STAFF REPORT	
COMMUNITY DEVELOPMENT DEPARTMENT

HEARING DATE: March 12, 2024
 TO: Mayor & City Council
 FROM: Sonya Allen, Associate Planner
 208-884-5533
 SUBJECT: Stonehill Church – MDA, RZ, PP, CUP
[H-2023-0041](#)
 LOCATION: 799 W. Amity Rd., in the north 1/2 of
 Section 36, T.3N., R.1W.

B. Preliminary Plat (dated: 7/6/23) & Roundabout Exhibit

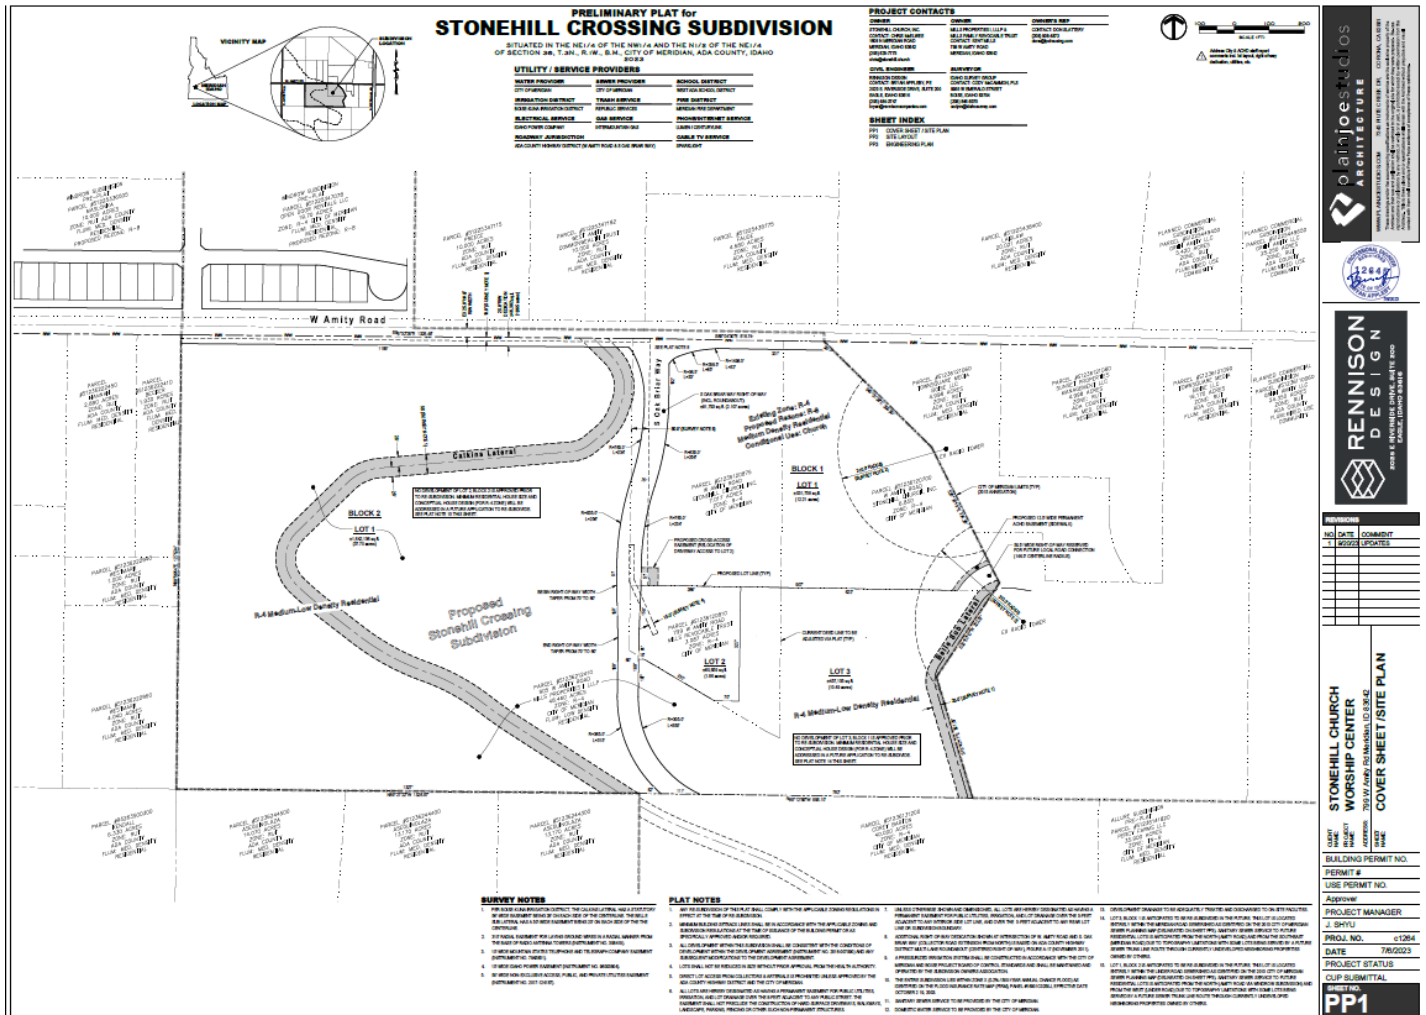
A collector street is proposed as depicted on the plat from W. Amity Rd. at the northern boundary of the site extending to the southern boundary of the site in accord with the Master Street Map (MSM). **A temporary cul-de-sac is required to be constructed at the terminus of the collector street at the south boundary with a minimum turning radius of 50' as required by ACHD.**

The MSM also depicts a multi-lane roundabout at the Amity Rd./Oak Briar Way intersection. The Applicant is required to dedicate right-of-way (ROW) for construction of the roundabout consistent with the template shown in the ACHD report. A roundabout exhibit was submitted, included in Section VIII.B, in accord with this template.

C. Preliminary Plat - Landscape Plan (dated: 9/25/2023)

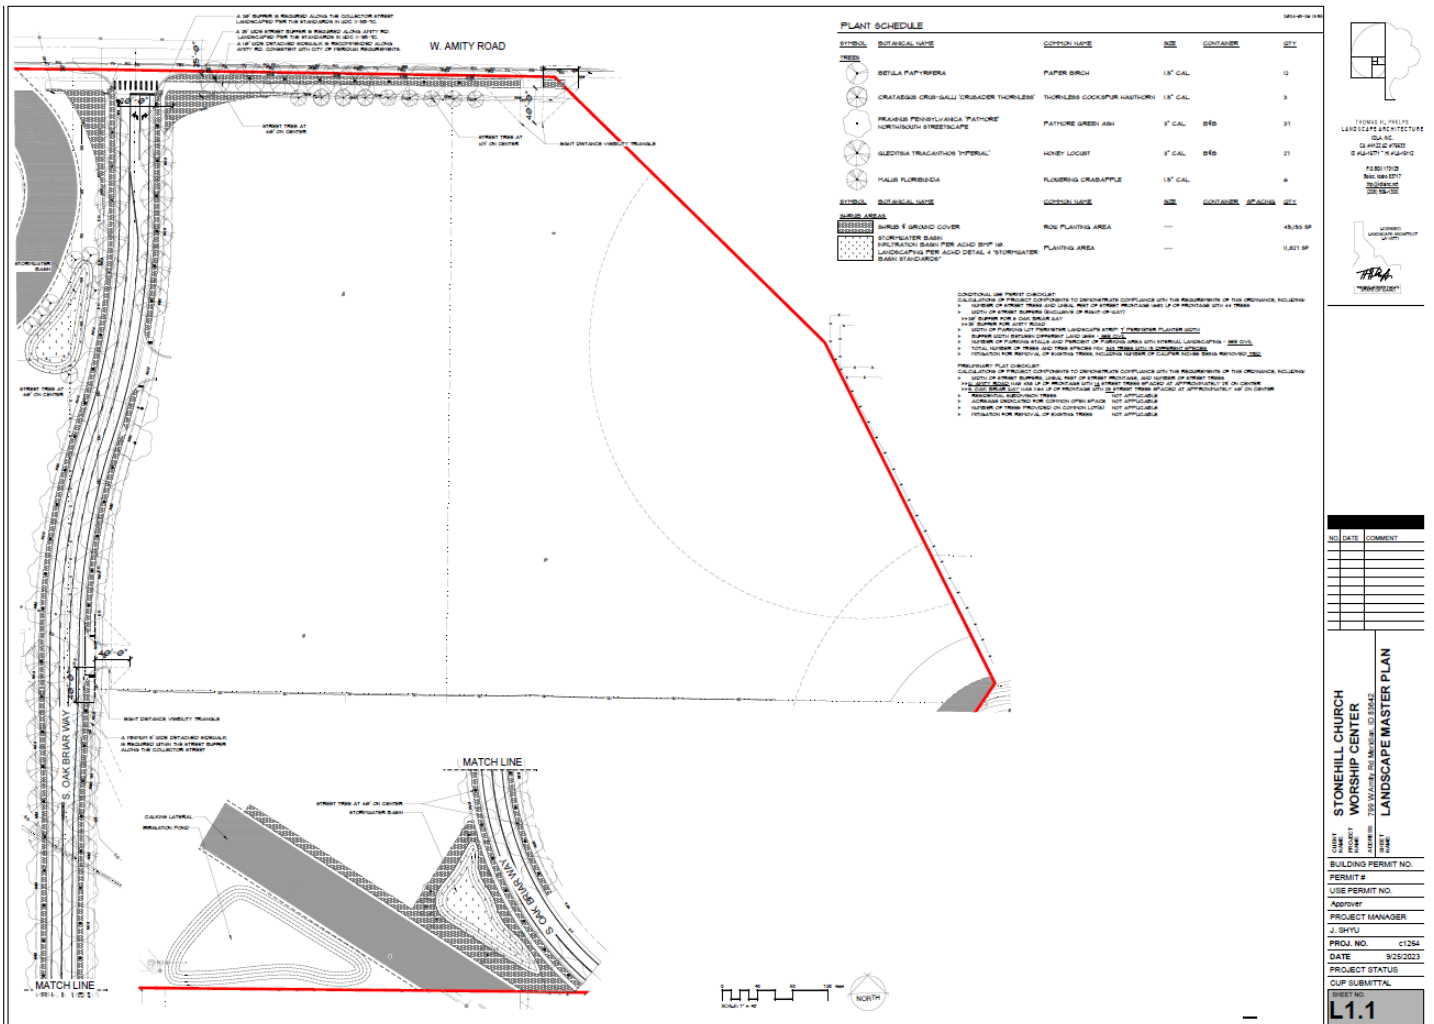
Landscaping: A 25-foot wide street buffer is required along W. Amity Rd., an arterial street, measured from *ultimate* back of curb location; and a 20-foot wide street buffer is required along S. Oak Briar Way measured from back of curb. **Landscaping is required to be installed within the buffers in accord with the standards listed in UDC [11-3B-7C.3](#); the proposed landscape plan should be revised to comply with these standards.**

Fencing: All fencing is required to comply with the standards listed in UDC [11-3A-6C](#) and [11-3A-7](#). Fencing is not depicted on the landscape plan.

- h. All sidewalks and parkways shall comply with the standards listed in UDC [11-3A-17](#).
- 2.2 The landscape plan submitted with the final plat shall include the following revisions:

D. Conceptual Development Plan for Future Resubdivision of Lot 3, Block 1 & Lot 1, Block 2 - REVISED

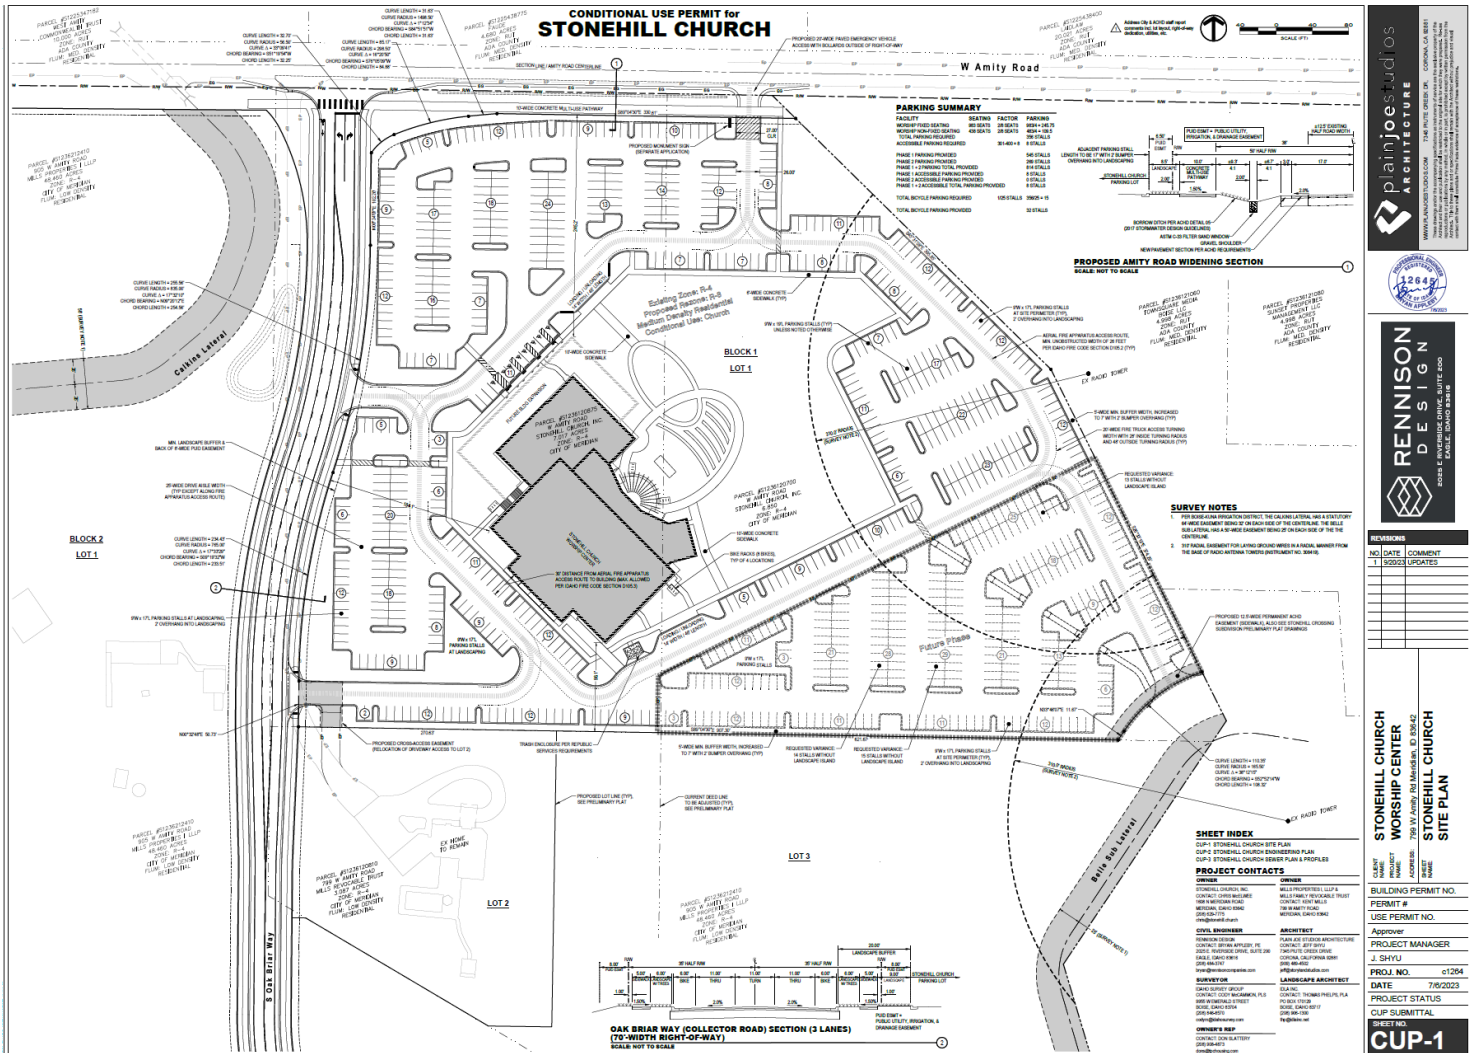
Conceptual Development Plan for Resubdivision: A conceptual development plan was submitted for a possible site layout for the future resubdivision of Lot 3, Block 1 and Lot 1, Block 2, as shown in Section VII.D. Future development is not tied to this plan as a DA modification is not proposed or required with this application. However, requested a development plan be submitted for this area for consideration. Staff offers the following comments on this plan:

- Dead end streets (i.e. Street C) should not be longer than 500’; however, City Council may approve a dead end street up to 750’ in length where an emergency access is proposed or a large waterway exists that prevents or makes impractical the extension or other conditions exists as noted in UDC [11-6C-3B.4](#). Although an emergency access via W. Amity Rd. is proposed and there is a large waterway that exists at the east end of the street, the dead end street exceeds 750’ at 870’ in length.

- Block faces are limited to 750’ in length without an intersecting street or alley, except Council may approve a block face up to 1,200’ where block design is constrained by site conditions such as an abutting arterial street or a large waterway and/or irrigation facility, among other conditions. The block face on the north side of Street C exceeds the minimum block face length allowed and would require approval from City Council as proposed.

- Stub streets should be provided to adjacent parcels for future extension and interconnectivity. A collector street is no longer required at the west end of the site along the southern boundary as the collector street has been moved to the south in alignment with Quartz Creek St. and is no longer needed in this location.

- The Applicant should consult the Irrigation District to see if a pedestrian bridge will be allowed across the Calkins Lateral.
- A local street should be provided between Lots 1 and 2, Block 1 from S. Oak Briar St. to the east end of Lot 2, Block 1, at a minimum, to reduce access points on the collector street and in accord with UDC [11-3A-3A.3](#), which requires all subdivisions to provide local street access to any use that currently takes direct access from an arterial or collector street.

- The Calkins Lateral and the Belle Sub Lateral are required to be piped unless used as a water amenity or linear open space as defined in UDC [11-1A-1](#) per UDC [11-3A-6B](#). The decision-making

body may waive this requirement if it finds that the public purpose requiring such will not be served and public safety can be preserved.

- If the Calkins Lateral and the Belle Sub Lateral are approved to be left open and not required to be piped and not improved as a water amenity or linear open space as noted above, fencing will be required to deter access to the laterals for public safety per the standards listed in UDC [11-3A-6C](#).
- Common open space and site amenities will be required in accord with the standards set forth in UDC [11-3G-3](#) and [11-3G-4](#).
- Access to the collector (i.e. S. Oak Briar Way) and arterial streets (i.e. W. Amity Rd.) is limited as set forth in UDC [11-3A-3A](#), unless otherwise waived by City Council.

E. Conditional Use Permit – Site Plan & Phasing Plan (dated: 7/6/2023 09/20/23) - REVISED

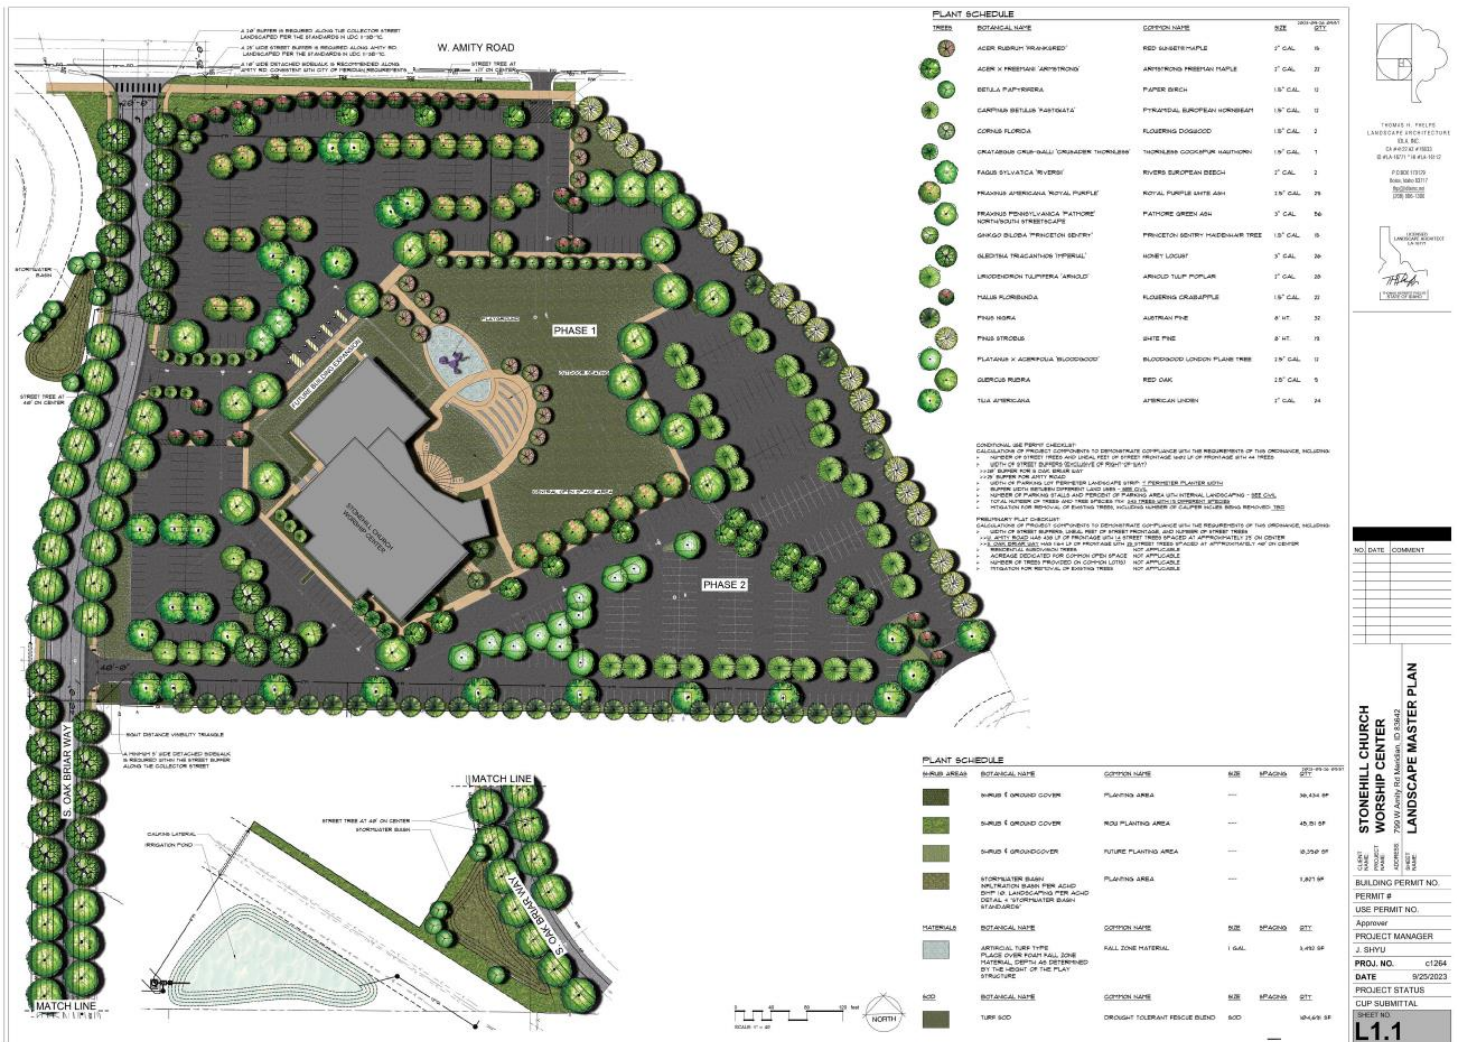
Access (UDC 11-3A-3): Three accesses are proposed to the future church on Lot 1, Block 1. Two (2) accesses are proposed via the collector street (S. Oak Briar Way) on Lot 1, Block 1; the northern access is proposed for the church and the southern access is proposed to be a shared access for the church and the existing residence. The other access at the east end of Lot 1, Block 1 via W. Amity Rd. is proposed is for emergency access only.

The UDC (11-3A-3) limits access points to collector and arterial streets to improve safety and to ensure that motorists can safely enter all streets, unless otherwise waived by City Council. Further, the UDC (11-3A-3A.1) requires all subdivisions to provide local street access to any use that currently takes direct access from an arterial or collector street. **The Applicant requests approval of a waiver from Council for the two (2) proposed accesses via the collector street (Oak Briar) proposed on Lot 1, Block 1.**

Because a subdivision is proposed, Staff recommends a street is constructed from the collector street (Oak Briar) between Lots 1 and 2, Block 1 to provide local street access to the church and the existing residence. A cul-de-sac or ACHD/Fire Dept. approved turnaround should be provided at the end of the street, which should extend to at least the eastern boundary of Lot 2, Block 1 but may extend further depending on the access needs of the church. This street should be extended in the future with resubdivision of Lot 3, Block 1.

Staff recommends bollards are constructed with a chain and a Knox padlock at the emergency access driveway via Amity Rd. to prohibit public access.

Parking: Off-street parking is required to be provided based on the square footage of the church per the standards set forth in UDC [11-3C-6B.1](#) for commercial districts (i.e. 1 space for every 500 s.f. of gross floor area). Based on a total of 52,000+/- s.f., including the future addition, a minimum of 104 spaces will be required. The Applicant proposes to provide 545+/- spaces with the first phase and 269+/- spaces with the second phase, which exceeds the minimum standards by 710+/- spaces.

Parking stalls and drive aisles should comply with the dimensions noted in UDC [Table 11-3C-5](#). Where parking spaces abut a sidewalk or a perimeter landscape buffer, wheel stops should be provided to prevent vehicle overhang or the length of the parking space may be reduced 2' if an additional 2' is added to the width of the sidewalk or the perimeter buffer to total 7' as set forth in UDC [11-3C-5B.4](#). **The site plan submitted with the Certificate of Zoning Compliance application should depict dimensions that demonstrate compliance with these standards.**

- 3.1 The site plan and landscape plan submitted with the Certificate of Zoning Compliance application shall be revised as follows:
 - a. All outdoor utility meters, HVAC equipment, trash dumpsters, trash compaction and other service functions shall be incorporated into the overall design of buildings and landscaping so that the visual and acoustic impacts of these functions are fully contained and out of view from adjacent properties and public streets as set forth in UDC [11-3A-12](#). Safe access and adequate lighting should be provided in these areas.

- f. Depict dimensions for parking stalls and drive aisles that comply with the dimensions noted in UDC [Table 11-3C-5](#). Where parking spaces abut a sidewalk or a perimeter landscape buffer, wheel stops should be provided in parking stalls to prevent vehicle overhang; *or*, the length of the parking stalls may be reduced 2' if an additional 2' is added to the width of the sidewalk or the perimeter buffer to total 7' as set forth in UDC [11-3C-5B.4](#).
